[Docket No. FAA-2006-25105; Directorate Identifier 2006-CE-33-AD; Amendment 39-15016; AD 2007-06-01 R1]

#### Airworthiness Directives; Raytheon Aircraft Company Beech Models 45 (YT-34), A45 (T-34A, B-45), and D45 (T-34B) Airplanes

**ACTION:** Final rule; correction.

**Appendix to AD 2007-06-01 R1—Surface Eddy Current Inspection Procedure**

Figure 1

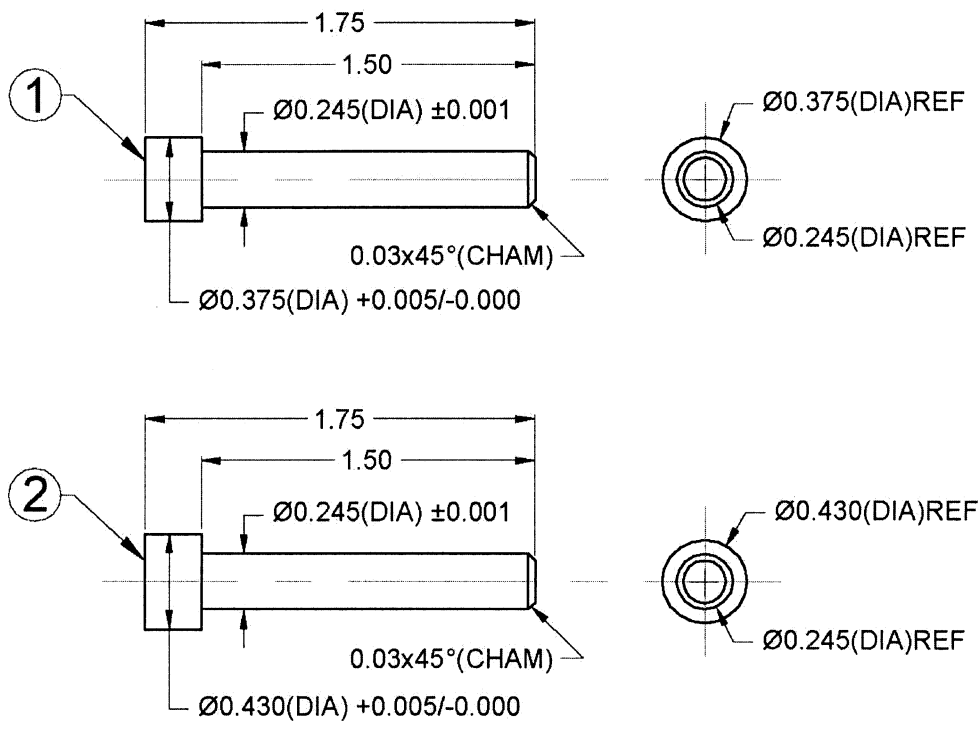
Typical Set-up Parameters:  
Frequency – 350 KHz, Gain Vertical – 75 dB, Horizontal – 69 dB, Drive-Mid, Filters-Lo Pass-30, Hi Pass-0, Lift off-Horizontal to the left, adjust as required. The most reliable indication (minimum of 1/2 to 2 graticules) of the smallest observable flaw in the coupon (see the attached Figures) occurs from the notch extending 0.025" past the edge of the nominal fastener head (total notch length of 0.100" from the edge of the nominal hole). Install appropriate aluminum guide pin into bushing such that the edge of the guide pin

is flush with the edge of the bushing. Using the pin (see the attached Figures) as a guide, circle the area surrounding the steel bushing with the probe and adjacent area (approximately 1/4") to inspect for cracks. Inspect forward and aft surfaces surrounding bushings of each spar.
